# ***SERVICE PROCEDURE***

**G-07504**  
**March 2007**

**SUBJECT: SAFETY RECALL (MEXICO, EXPORT)**  
**AIR BRAKE TUBING on 4300 and 4400 tractors built**  
**6/21/2004 thru 2/21/2007**

**Figure 1**

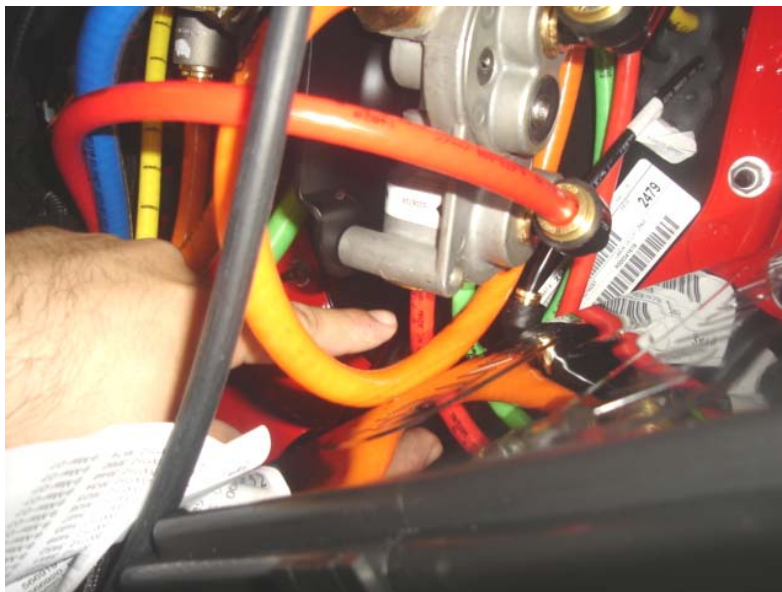
1. Drain the vehicle's air tanks by repeatedly depressing the brake pedal or opening the tank drain valves.
2. Open vehicle hood. Locate and remove the single 3/8" OD RED air brake tube located on the bottom side of the TP-5 Tractor Protection Valve, mounted on the driver's side of the firewall.

**Figure 2**

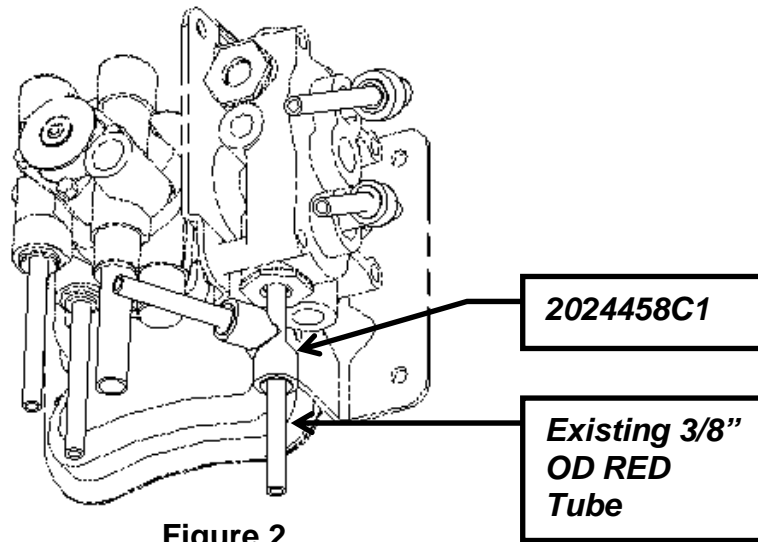
3. Install quick connect tee (2024458C1) into port where single 3/8" OD RED tube was located.

**Figure 3**

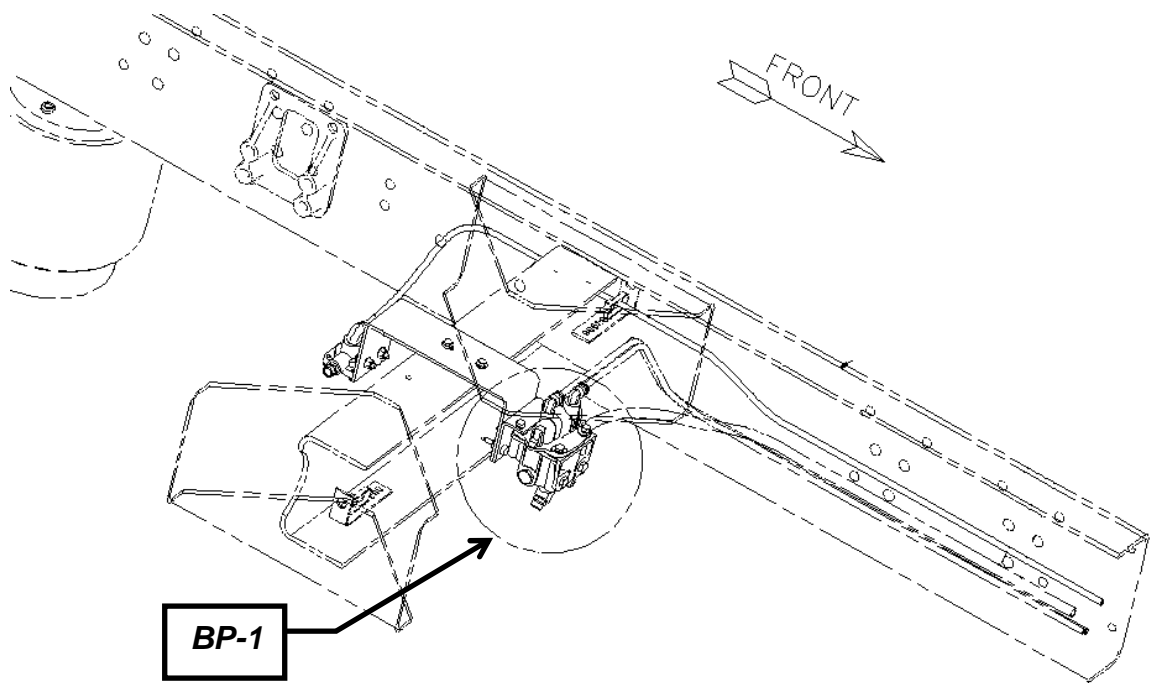
4. Locate the BP-1 Bobtail Proportioning valve on the rear frame cross member.

**Figure 4**

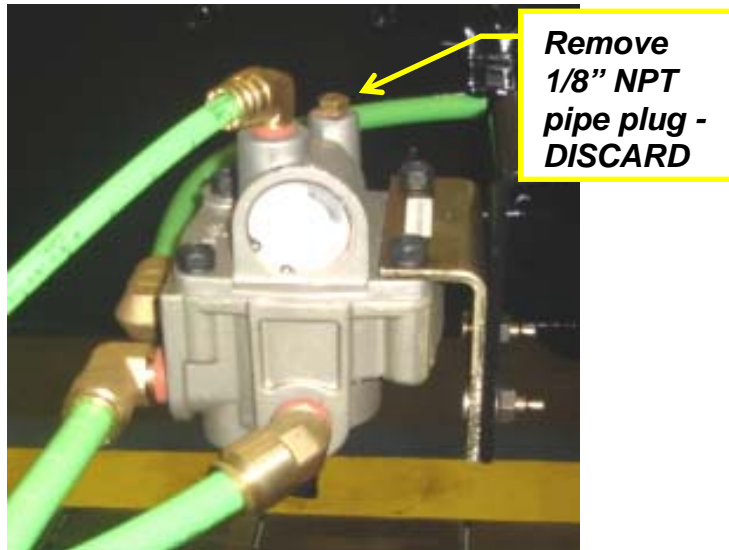
5. Remove 1/8" NPT plug from BP1 valve.

**Figure 5**

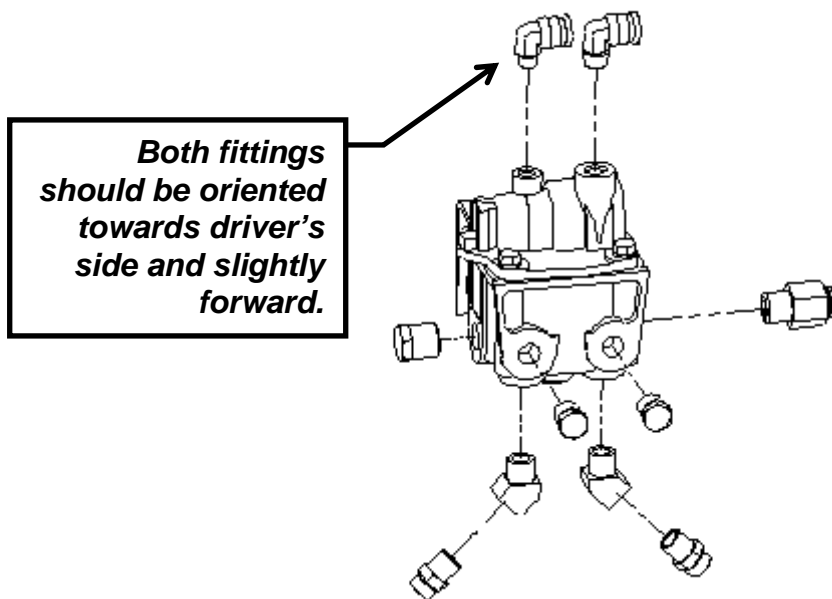
6. Clean threads if necessary.
7. Install elbow (2017509C1). Orient fitting toward driver's side as shown.
